Re: Planning Proposal - PP/2021/1/1

Proposed amendment to the Growth Centres SEPP to facilitate an increase to the maximum building height for residential development surrounding Oran Park House and accompanying DCP amendment.

Re: DA 2021/77/1

4 O'Keefe Drive, 57E Banfield Drive and 73 Banfield Drive ORAN PARK
*Concept DA for approval of site-specific building height development standards on
66 residential lots and construction of 3 single storey dwellings*

Source: *Urbanco 25 January 2021 Statement of Environmental Effects (SEE)*

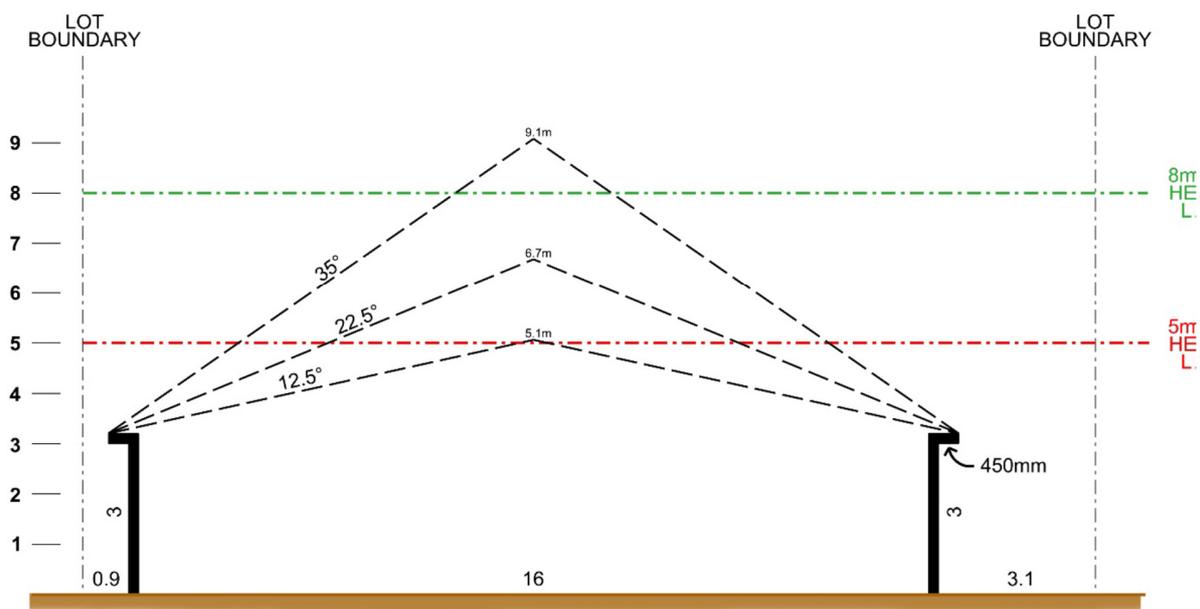
Of course, the wider the house the higher the roof needs to be to attain the required pitch. The assumption is that the whole building will be under one continuous roof, rather than having the roof form broken up, or even having the garage under a separate roof.

A lateral approach seeking a finer grained low-scale, more traditional and less dense residential character is needed to reconcile the required roof-pitch to the height constraint. It is concerning that only one design approach is cherry picked to prosecute the argument for a 37.5% increase in the height limit.
